DOCUMENT TITLE  
**SERVICE INSTRUCTION WSI DF-431B-18  
 IMPROVE MISMATCH AND  
 RADIO SENSITIVITY**

SIZE <b>A</b>	LRU <b>DF-431B</b>	DOCUMENT NUMBER <b>150-043453-18</b>	REV <b>A</b>
------------------	-----------------------	---	-----------------

**SERVICE INSTRUCTION NUMBER: WSI DF-431B-18**

Figure 1

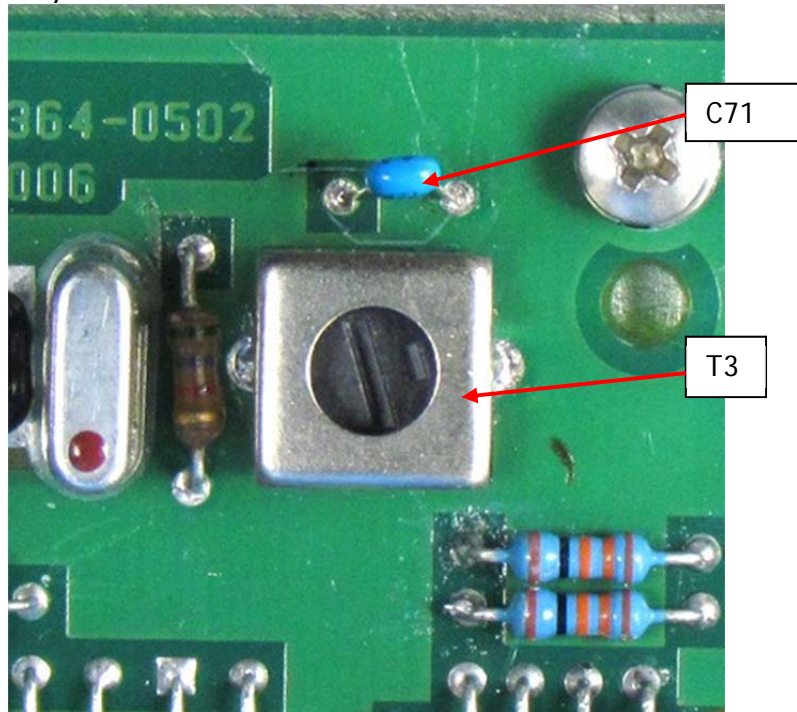
This WSI is only applicable to units that exhibit more than 0.5 degrees offset when changing from high field strength (1000uV/m) to lower field strength (100uV/m) AND have a transformer (T3) on the Receiver Board (200-07590-0000) that does not have "Toko" on the lid or a sticker with p/n 118-243436.

This Work Instruction applies to the DF-431B Receiver Board (200-07590-0000) and requires changing a capacitor value (C71) and reworking a transformer (T3).

1. Remove C71 from Receiver board shown in
2. Figure 1.
3. Replace C71 with Item 1.
4. Replace or rework T3 .
  - a. Replace T3 (Option 1)
    - i. Remove T3.

- xi. Solder reworked part back into receiver board at T3 location shown in Figure 1.

<b>ITEM</b>	<b>QTY</b>	<b>U/M</b>	<b>PART NUMBER</b>	<b>DESCRIPTION</b>	<b>REF</b>
1	1	EA	109-00025-0010	Cap, Mono-Ceramic 47pF	C71
2	1*	EA	118-243436	Transformer, Variable	T3

Figure 2

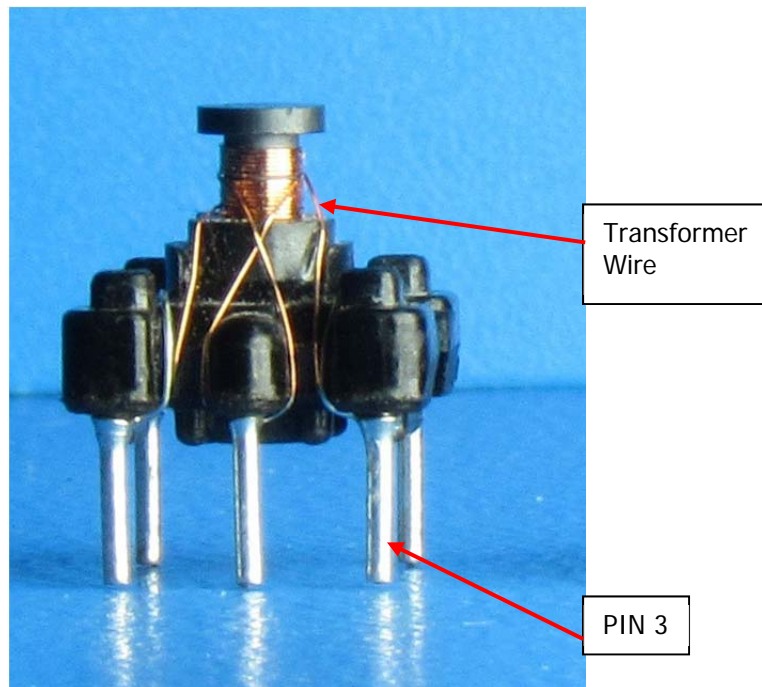
- iv. Unsolder transformer wire from Pin 3 shown in Figure 2.  
\*\*Ensure only the transformer wire is removed from Pin 3 (copper color), a silver wire leading up and through the transformer to a capacitor underneath is also present, do not remove this wire.

- v. Remove 3 turns from center post in a counter clockwise direction when viewed from above.
    - vi. Wrap wire twice around base of Pin 3, solder wire in place.
